Access Report

Collaroy Living Residences 37-43 Hay Street COLLAROY NSW

Ref: LP\_22521

Development application documentation for the proposed seniors living development – Collaroy Living Residences – located at 37-43 Hay Street Collaroy has been reviewed against current and applicable accessibility legislation.

Figure 2 | Overall Site Plan

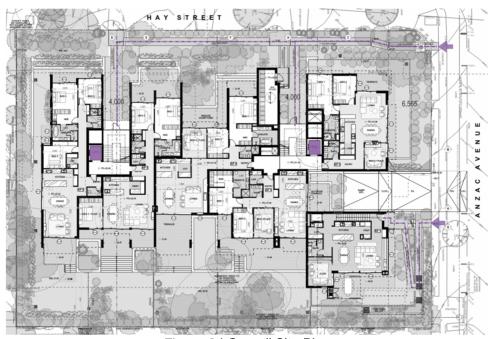
- from the allotment boundary at the pedestrian entrance along Hay Street and Anzac Avenue to the building entrance
- from the carparking area to the building entrance.

An accessible path of travel is provided to the building / apartment entrances from the allotment boundaries along Hay Street and Anzac Avenue. A system of walkways and ramps is provided.
